Memorandum

June 17, 2008

TO: Columbia River Crossing Task Force
FROM: CRC Pedestrian and Bicycle Advisory Committee (PBAC)
SUBJECT: PBAC Recommendations for World Class Pedestrian and Bicycle Facilities

PBAC Proposed Pedestrian and Bicycle System for Replacement Bridge

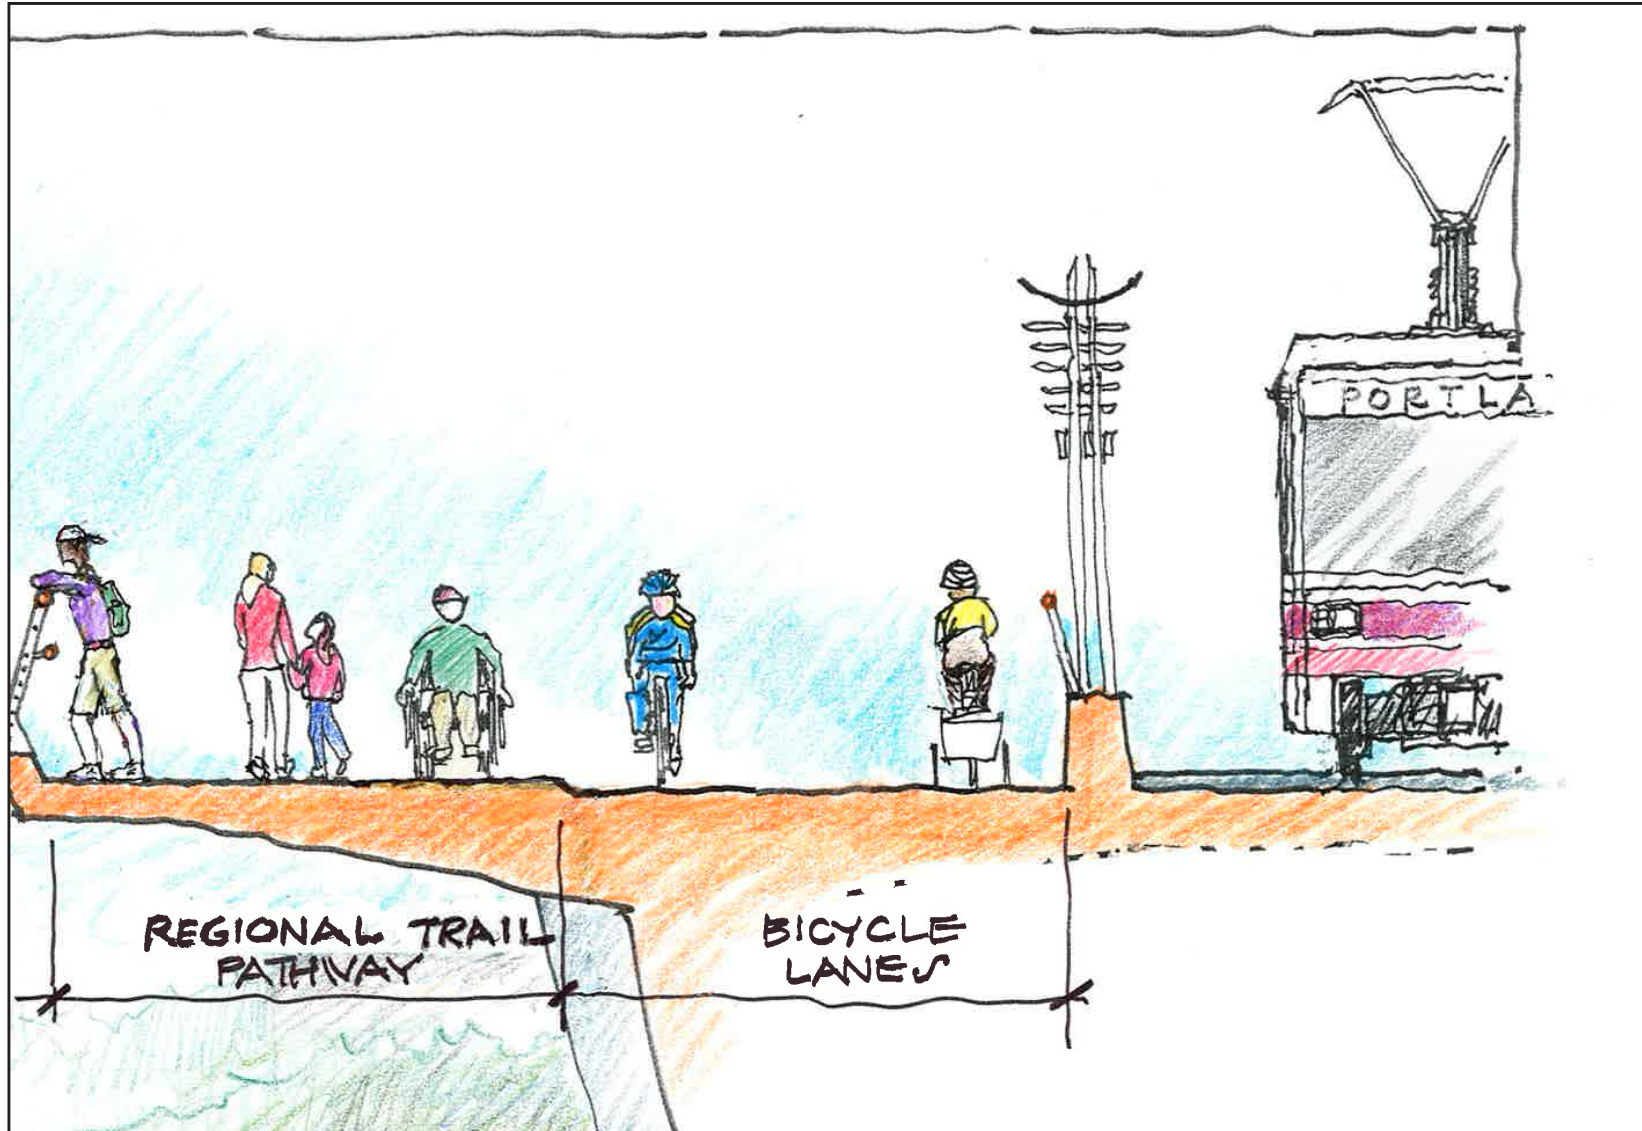
- The overall pathway on the western bridge (adjacent to the transit guideway) must provide separation between recreational users and higher speed bicycle users. To provide this separation, a 12-foot wide regional trail should be provided adjacent to, and to the west of, a pair of six-foot wide bicycle lanes (see attached rendering). These recommended widths are exclusive of potentially needed shy distances, i.e., free and clear of poles and other obstructions to enable safe pedestrian and bicycle movement (a summary of agency standards for multiuse paths, sidewalks and bike lanes is attached).

- In addition to the combined regional trail and bicycle lanes on the western bridge, an eight-foot wide sidewalk should be provided on the eastern bridge (the bridge that would serve the northbound traffic lanes) across both the Columbia River and the North Portland Harbor. The sidewalk across the North Portland Harbor would touch down on Hayden Island and use surface street sidewalks to connect to the sidewalk across the Columbia River.
